PLANNING & ZONING COMMISSION

MEETING AGENDA

2. Consideration and possible action on the Final Plat of Marley Meadows being 19.653 acres, located in the City of Sanger's ETJ, and generally located on the west side of Sam Bass Road and approximately 1307 feet north of the intersection of FM 455 and Sam Bass Road.

Project Name: Marley Meadows
 Final Plat
 Project: 24SANZON-0001

SANGER, TEXAS
 GRADING PLAN
 FOR
 MARLEY MEADOWS

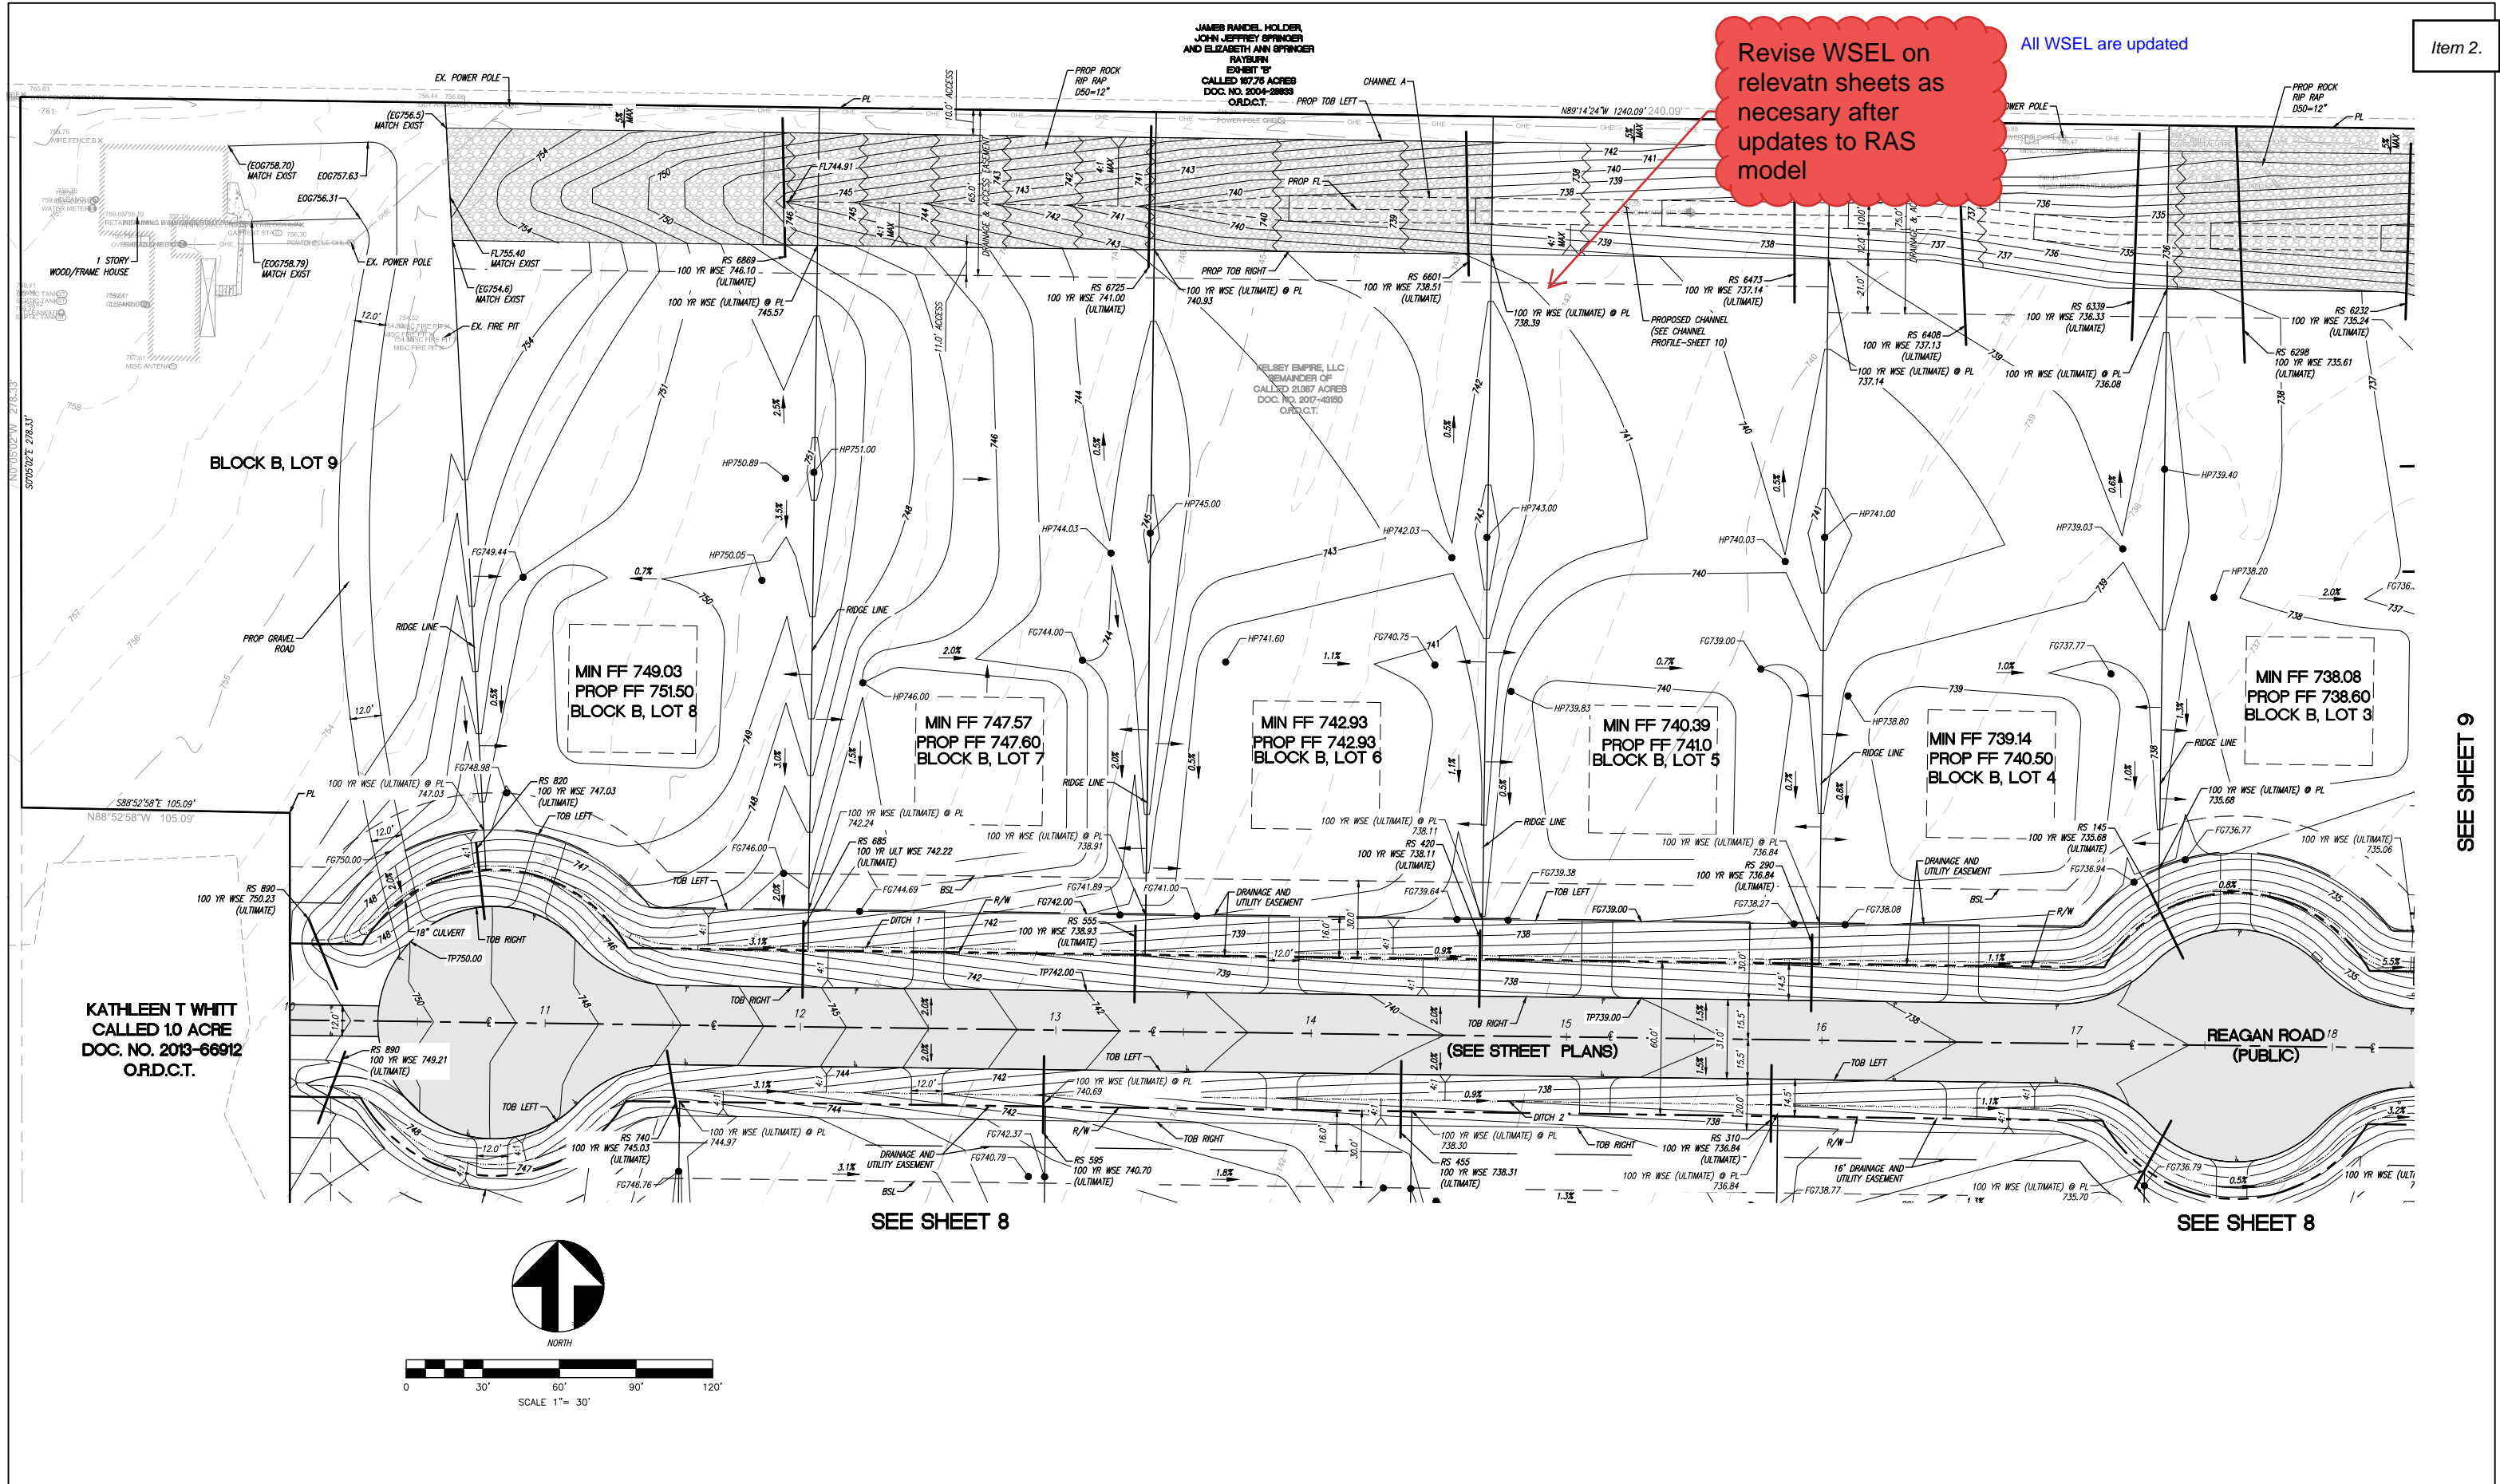
Revise WSEL on relevant sheets as necessary after updates to RAS model

Cannot locate WSEL/
profile to verify
elevations for Ditch
10 DCSRR IV.3.4

As discussed on the meeting with Leigh A. Hollis, normal depth would be sufficient and profile for this ditch is not required

SECTION J-J
NTS

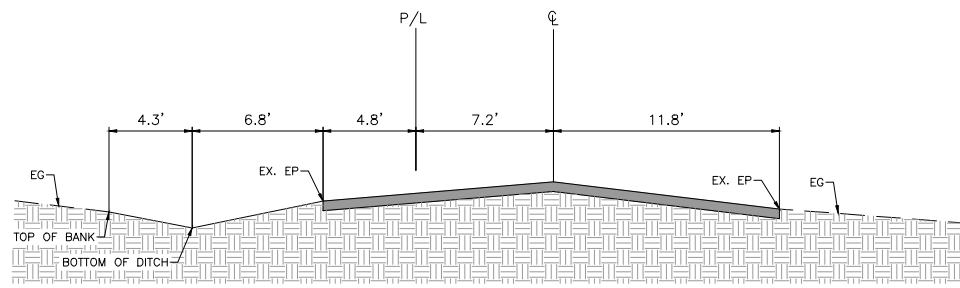
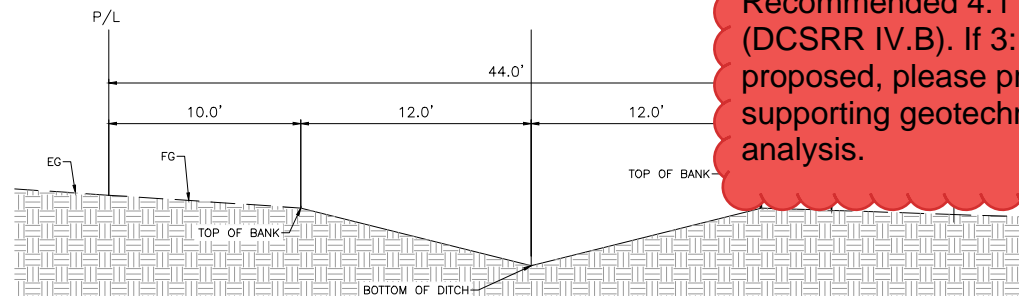
Recommended 4:1 max slope (DCSRR IV.B). If 3:1 is proposed, please provide supporting geotechnical analysis.

Revised to 4:1 max slope

HEC-RAS Plan: CHANNEL-A PROP CONDITION River: CHANNEL-A Reach: CHANNEL-A

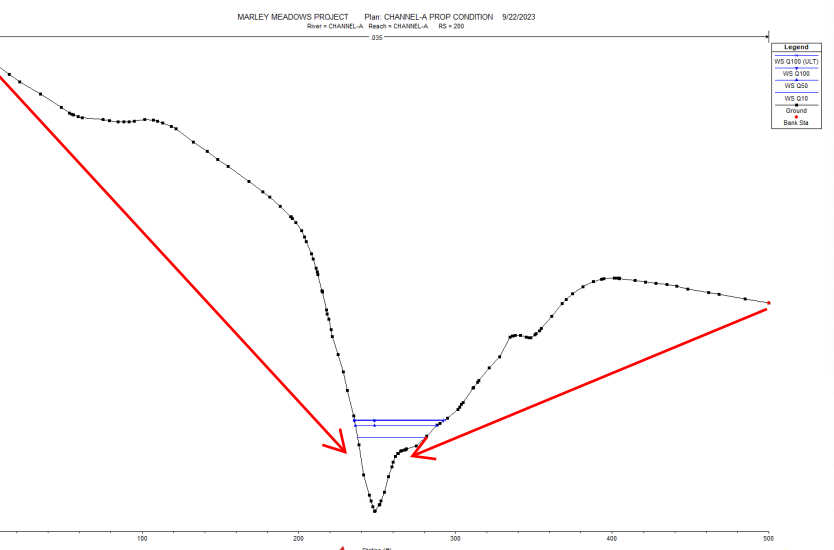
Critical depth still exists

This section barely have any flow. Rip-Rap is provided

PROJECT NO.
 sheet
 12-B
 of
 23

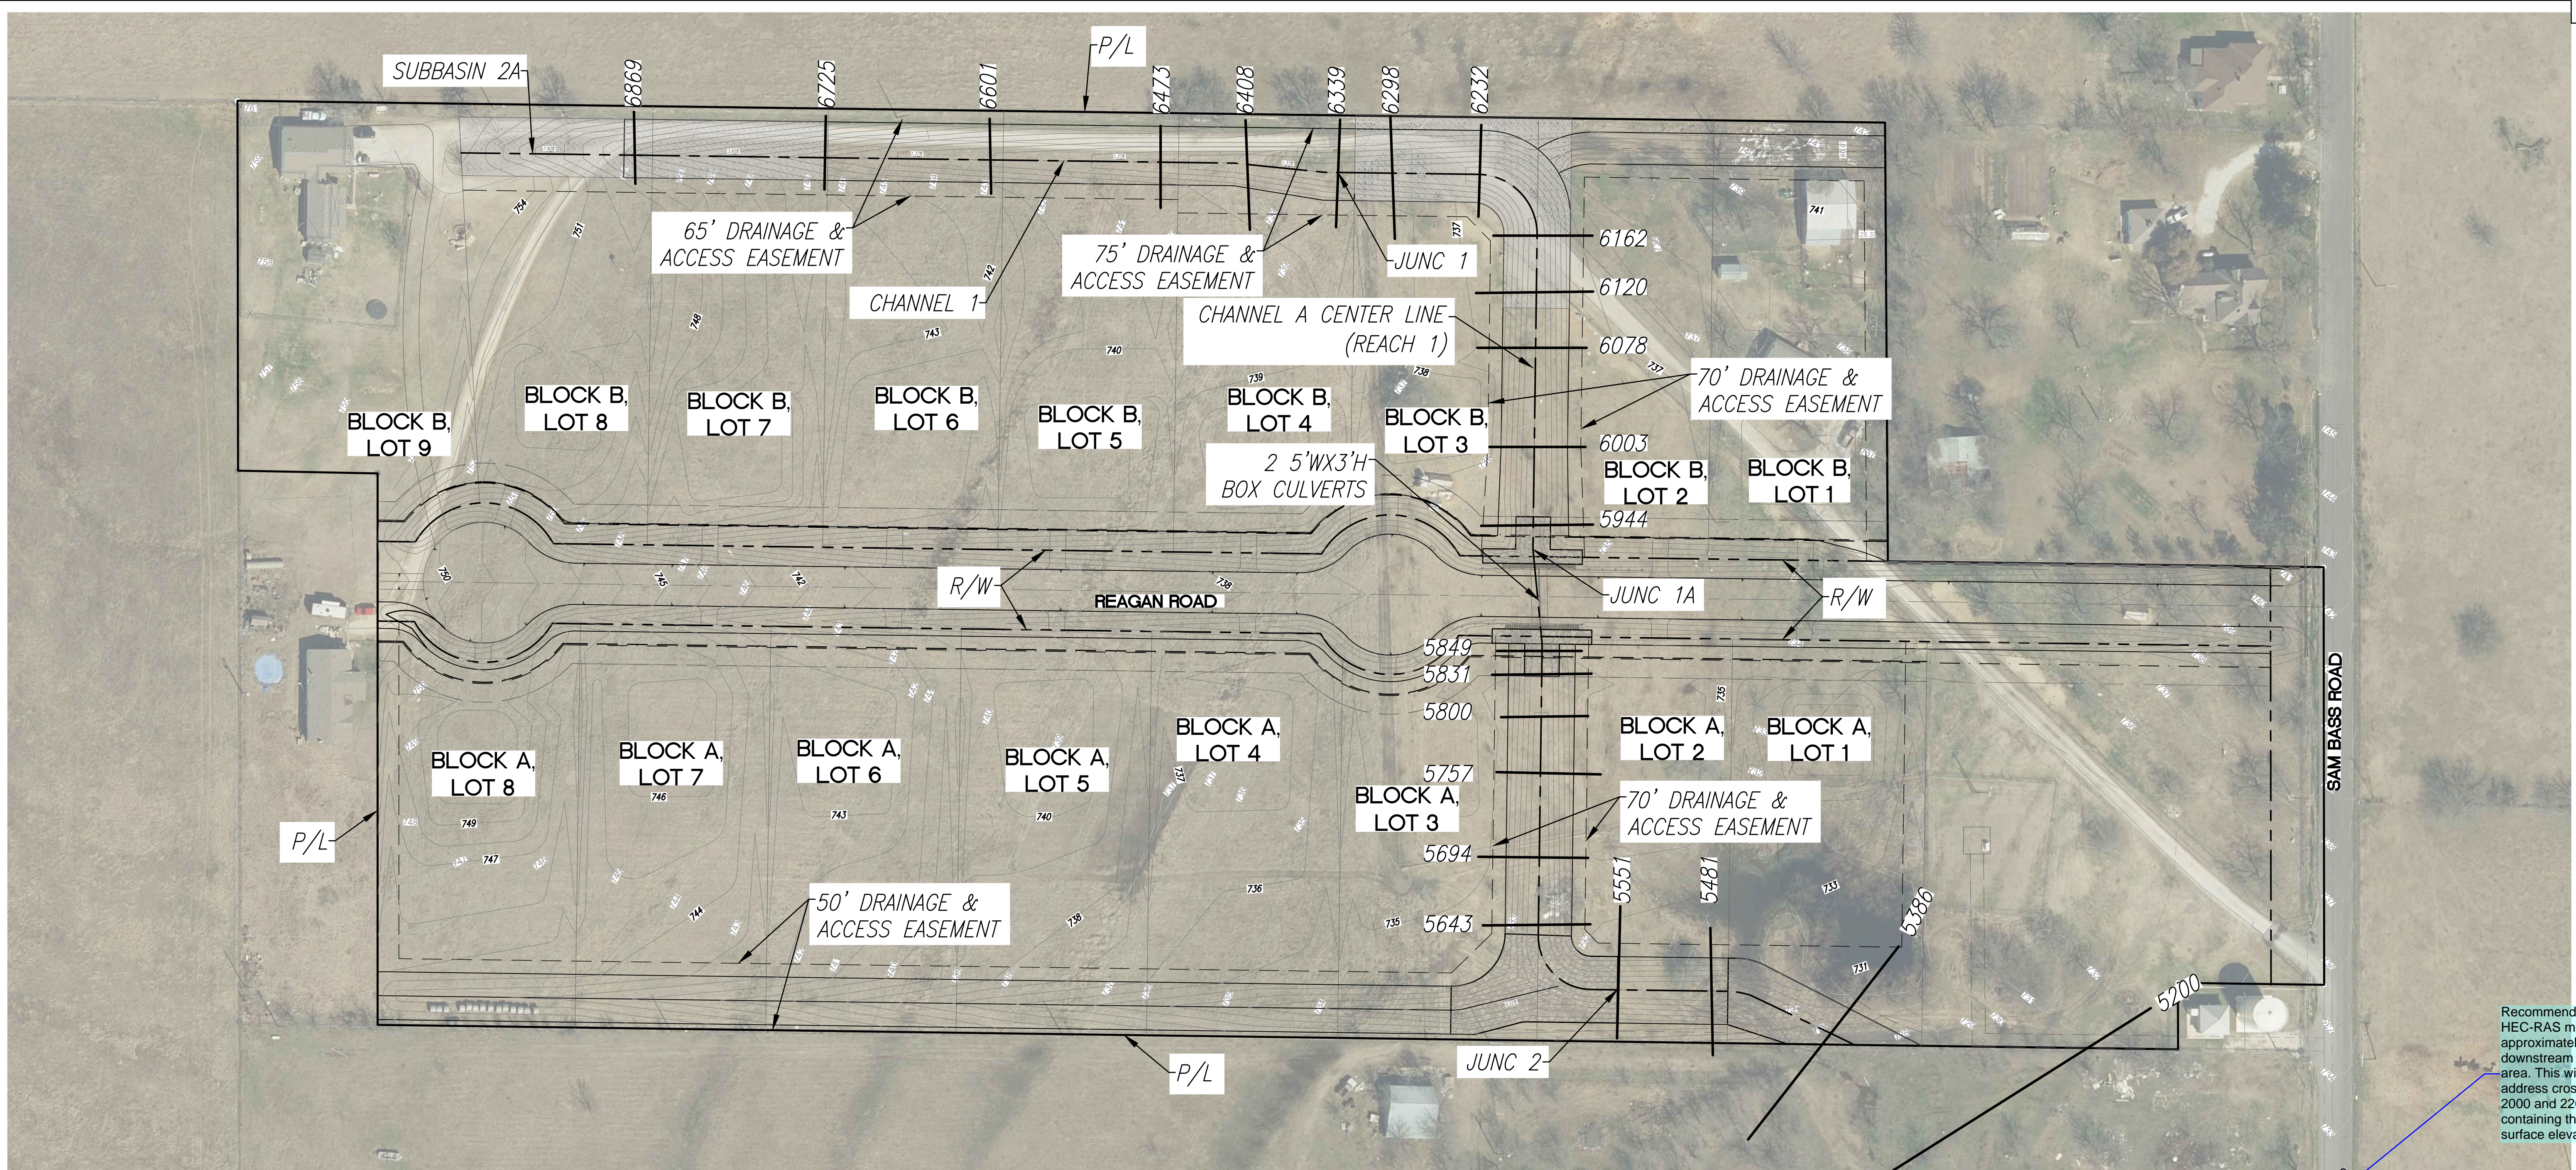
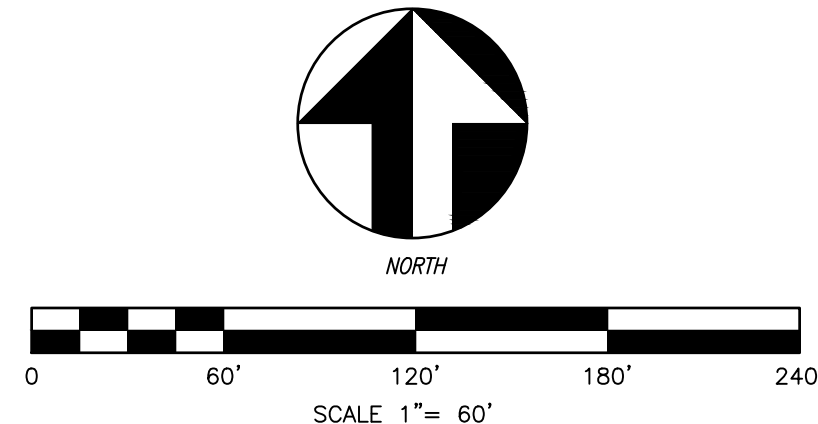
Recommend starting HEC-RAS model approximately 1,000 ft downstream of project area. This will also address cross sections 2000 and 2200 not containing the water surface elevation.

HEC-RAS model: N-values should be defined for the left overbank, channel, and right overbank at a minimum. One (1) n-value should not be used for the entire length of the cross section.
